Keithley Instruments
28775 Aurora Road
Cleveland, Ohio 44139
1-800-833-9200
tek.com/keithley

This firmware is used on the following Keithley Instruments product models:

Model 2450 Interactive SourceMeter® Instrument, 2450-NFP, 2450-RACK, 2450-NFP-RACK

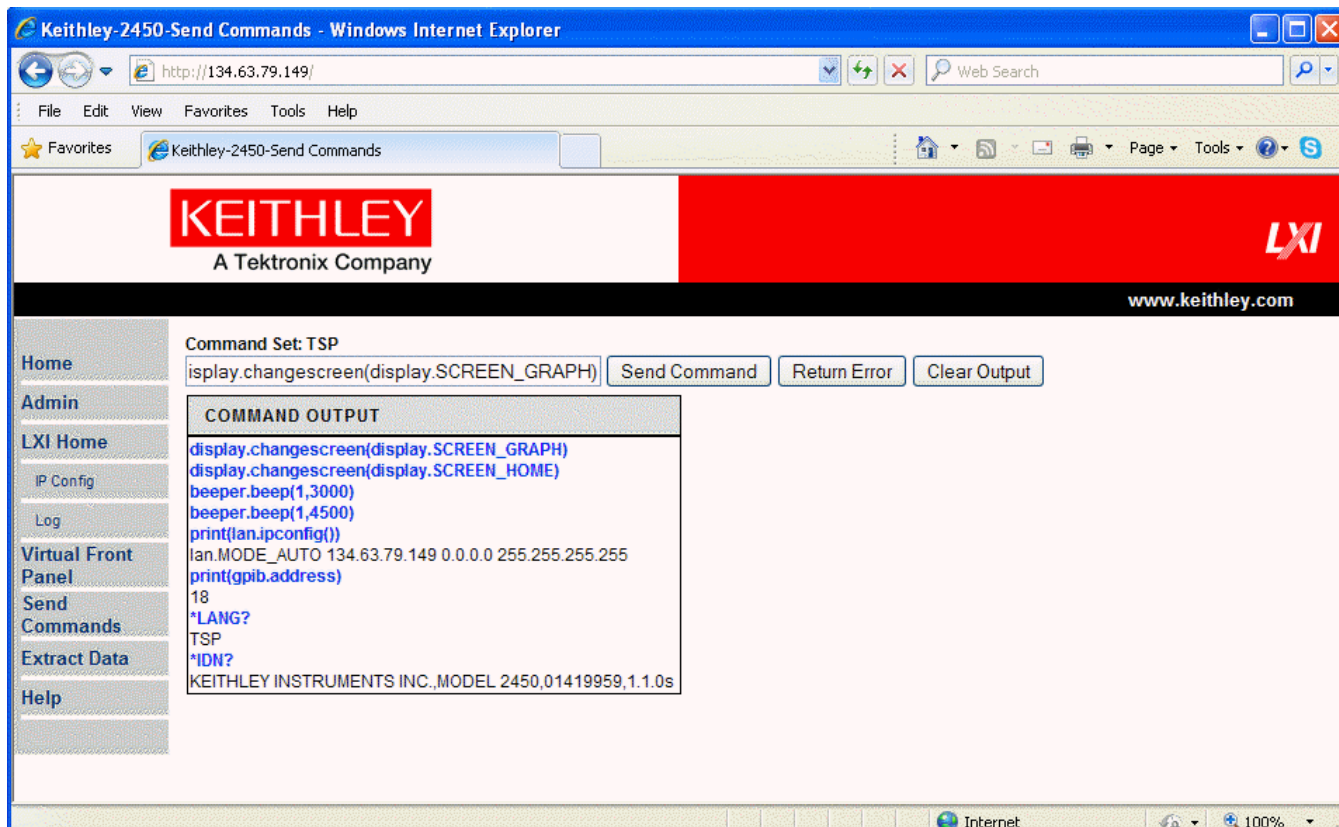
Enhancement:

The behavior of the *LANG? command on the 2450 has been changed as follows.

Sending the query *LANG? over a non-controlling interface will no longer change the interface control of the unit. For example, if the unit is under local control, then sending the *LANG? over Telnet, USB, or GPIB will leave the unit under local control. This was done in order for KickStart (or any other remote control software) to query connected/accessible instruments without resetting them or changing or disturbing the current trigger model.

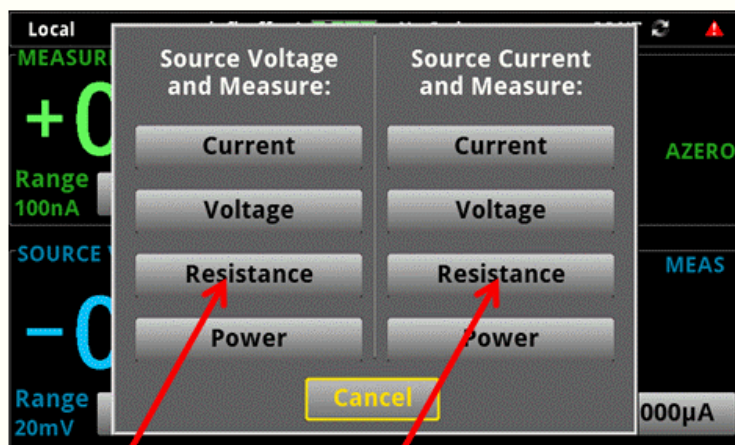
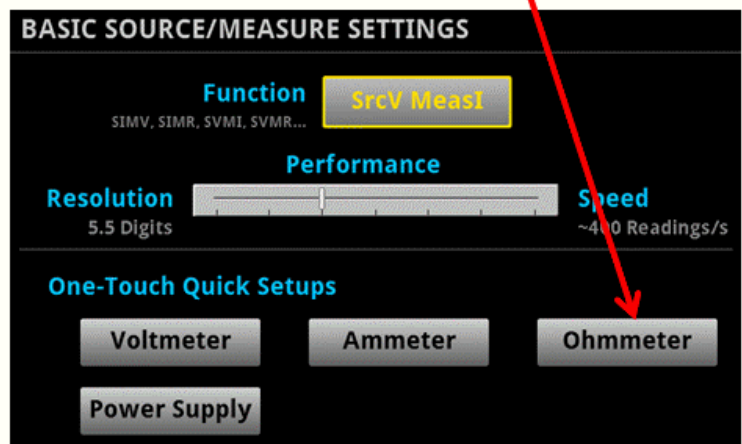
- f. New TSP Command Usage:
 - i. “Manual Ohms” → Measures resistance by sourcing voltage, measuring current, and calculating the resistance reading.
 - `smu.source.func = smu.FUNC_DC_VOLTAGE`

- `smu.measure.func = smu.FUNC_DC_CURRENT`
 - `smu.measure.unit = smu.UNIT_OHM`

- `smu.source.func = smu.FUNC_DC_CURRENT`
 - `smu.voltage.func = smu.FUNC_DC_VOLTAGE`
 - `smu.measure.unit = smu.UNIT_OHM`
 - ii. “Auto Ohms” → Measures resistance by sourcing current, measuring voltage, and calculating the resistance reading. In this case, the source current and source limit are automatically calculated and set.
 - `smu.measure.func = smu.FUNC_RESISTANCE`

Both exhibit "Manual" Ohms behavior (works just like Power by setting units to Ohms and going to SVMI or SIMV)

Exhibits "Auto" Ohms behavior
